**42 HAMPSTEAD LANE
LONDON, N6 4LL**

NMA APPLICATION 1
NOVEMBER 2022

SUMMARY OF CHANGES

CONSENTED VS NMA 1 PROPOSALS

NMA 1

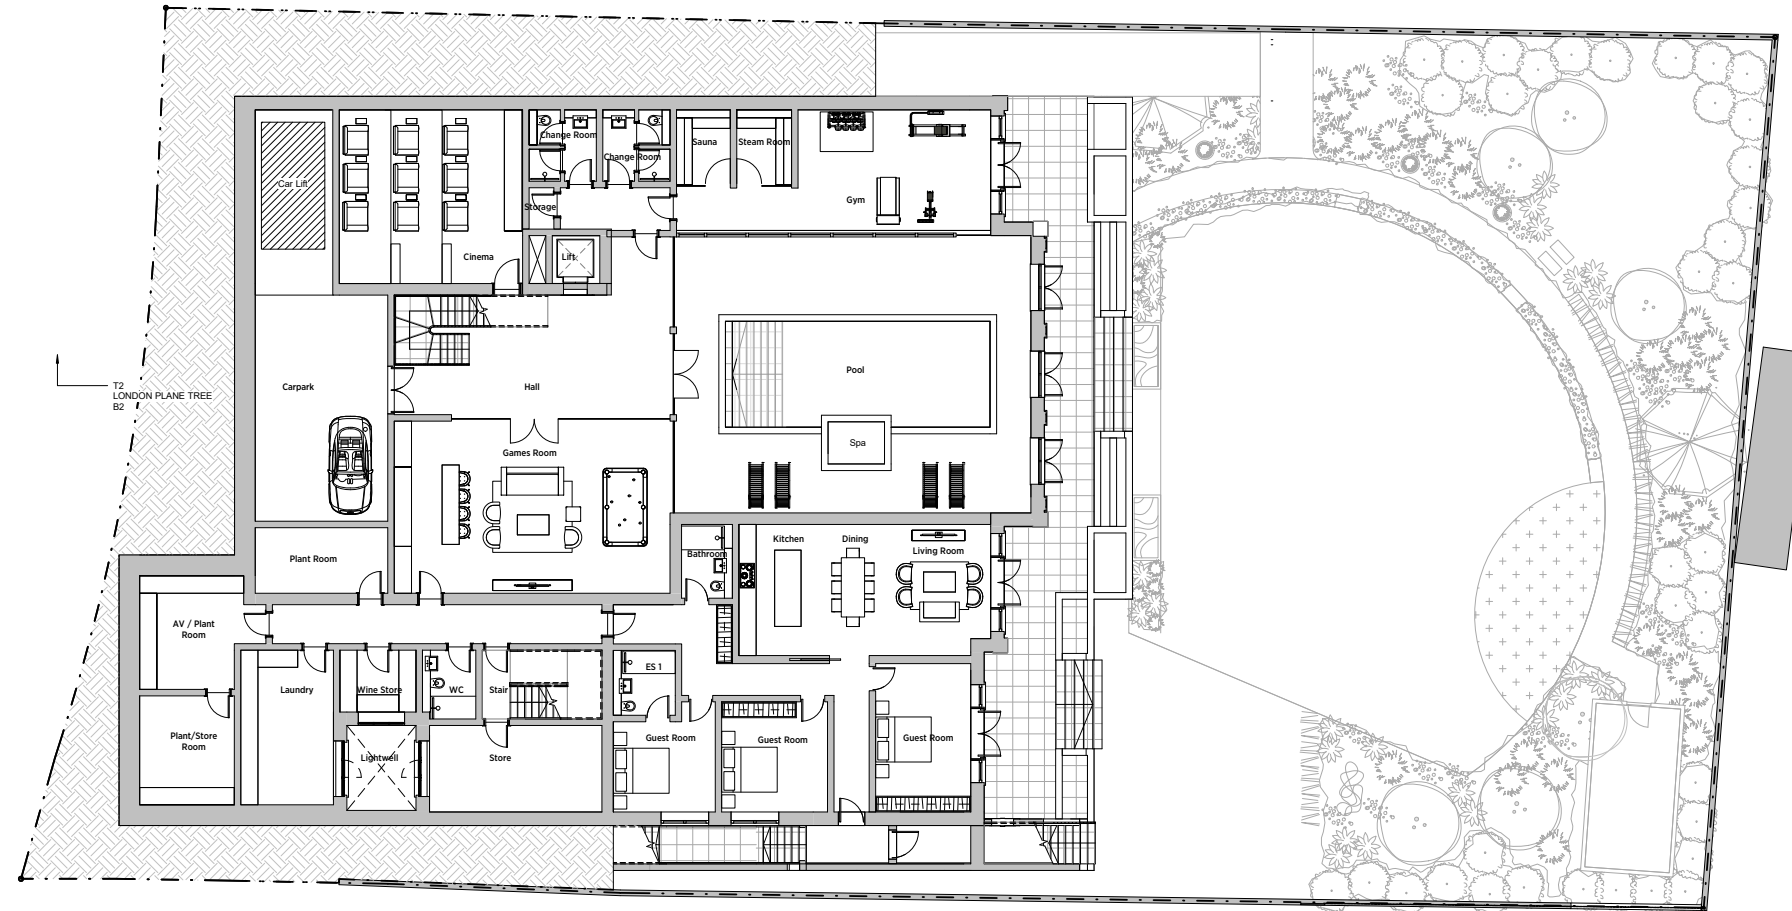
1. New solid door to front facade.
2. Windows to west facade repositioned and shape updated.
3. Kitchen window omission to east facade.
4. LGF door and window reconfiguration.
5. New door and new small gate for dog's shed to rear stairs.
6. Lift overrun.
7. Rear windows to GF Fromal living to be arched.
8. Glazed overhead panel to front door omitted.
9. Increased basement excavation under West Side ramp.
10. Ground floor and First Floor quoins to be stone & central rear bay quoins omitted.
 11. Roof lights to be repositions / omitted.
 12. Stone fascia added to front and rear dormers.
 13. Rear external staircase reconfiguration.
 14. Reconfiguration of rear facade windows.
 15. Orangery composition updated.
 16. Roof hatch added for maintenance.
 17. Chimneys update

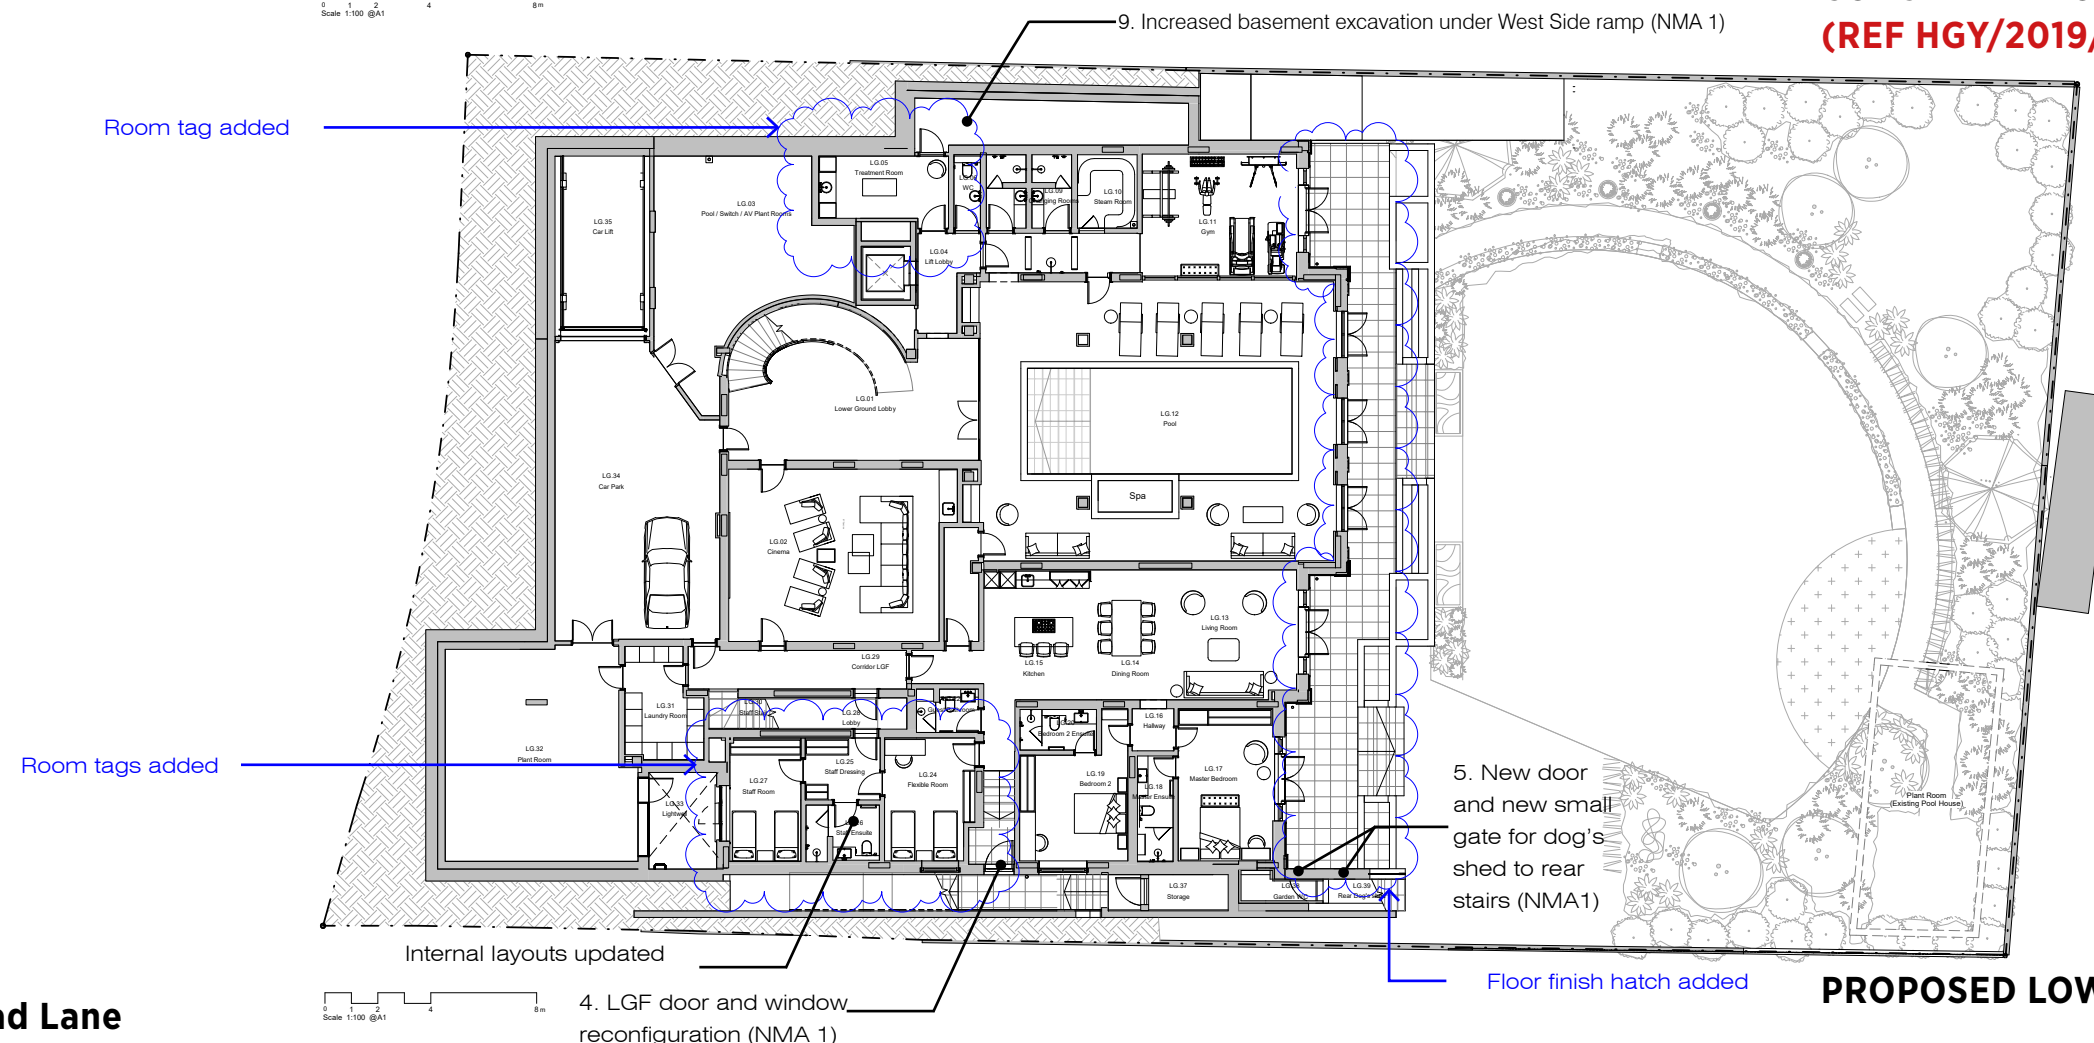
NMA 1	NMA 2
1. New solid door to front facade	NMA 1 +
2. Windows to west facade repositioned and shape updated	18. All sash windows to be casement.
3. Kitchen window omission to east facade	19. All glazing bars to windows omitted.

4. LGF door and window reconfiguration.	20. Rear Lower Ground Floor windows be sliding doors.
5. New door and new small gate for dog's shed to rear stairs

6. Lift overrun.	
7. Rear windows to GF Formal living to be arched.	
8. Glazed overhead panel to front door omitted	
9. Increased basement excavation under West Side ramp.

10. Ground floor and First Floor quoins to be stone & central rear bay quoins omitted	
11. Roof lights to be repositions / omitted.	
12. Stone fascia added to front and rear dormers

13. External rear staircase reconfiguration	
14. Reconfiguration of rear facade windows.	
15. Orangery composition updated.	
16. Roof hatch added for maintenance.

17. Chimneys update.

PROPOSED FRONT DORMER

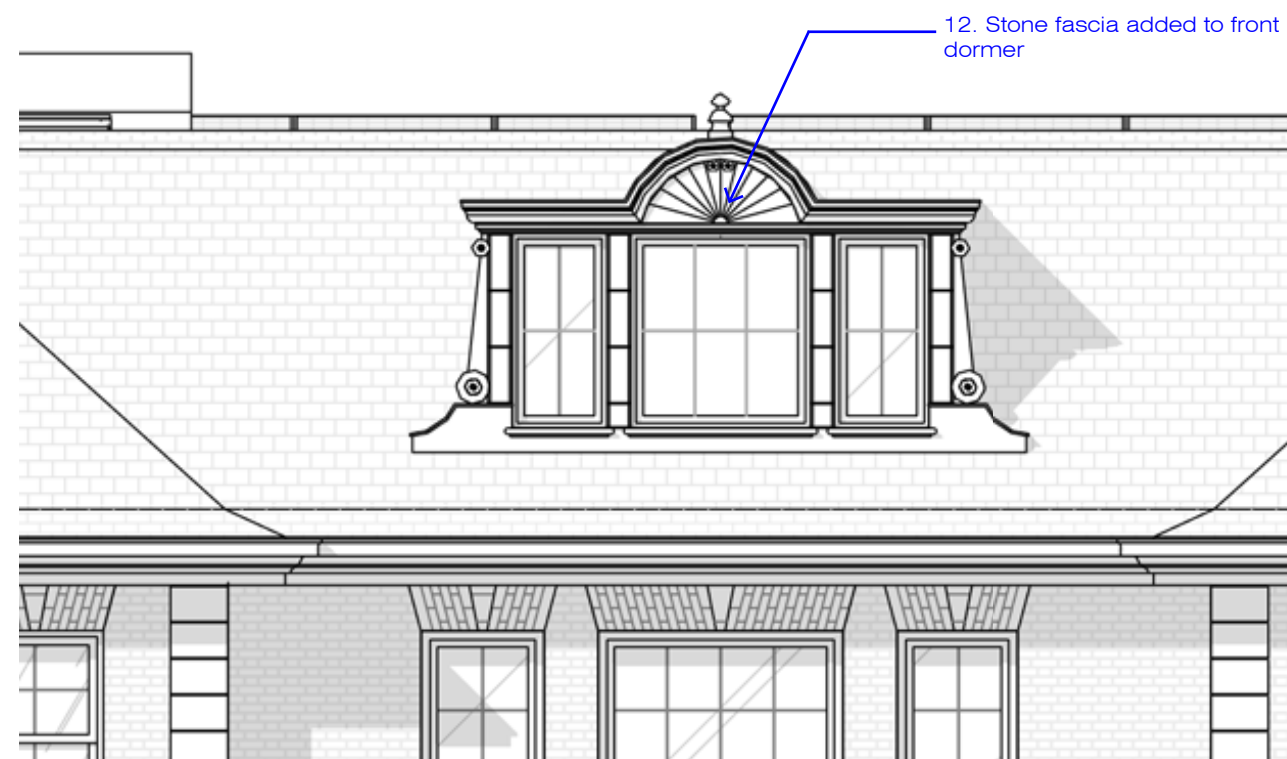
Page added to clarify proposed
front dormer

PROPOSED REAR DORMER

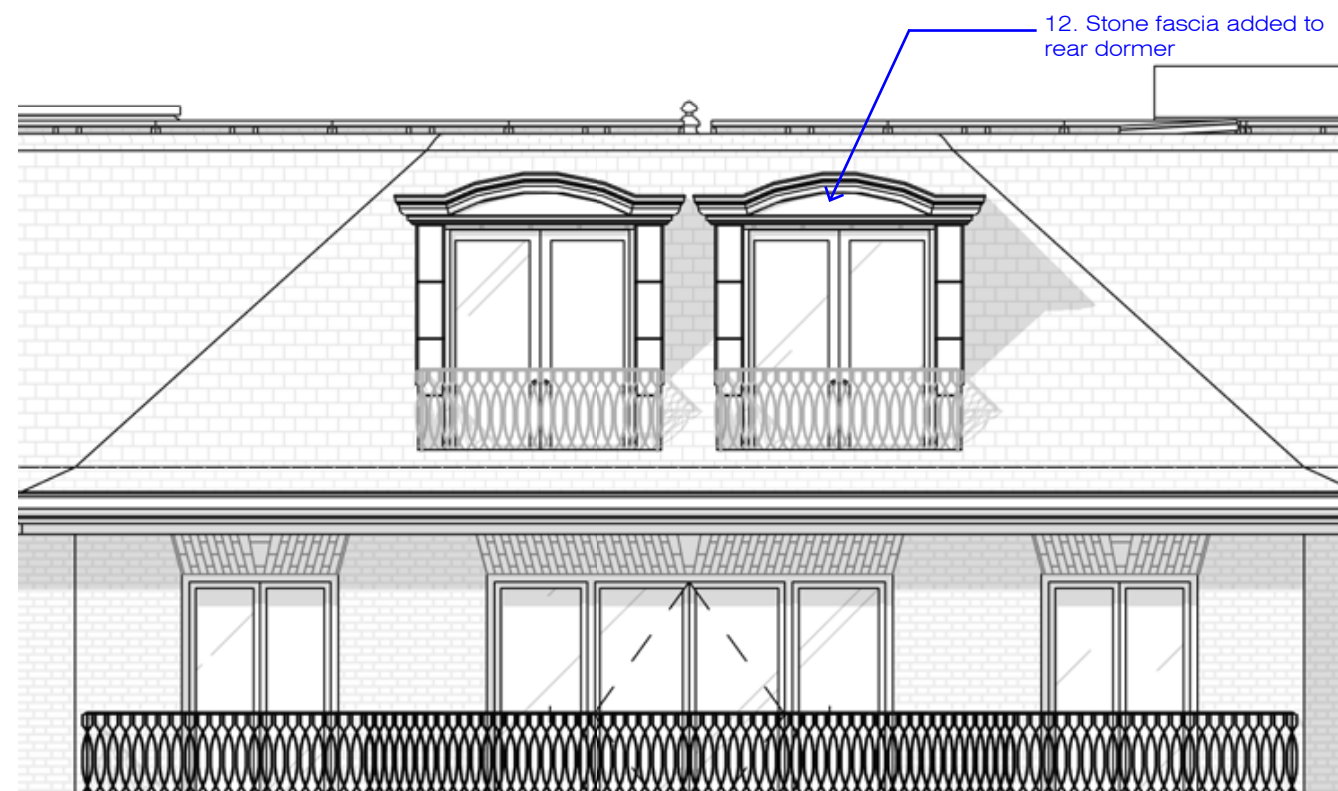
Page added to clarify proposed
rear dormer
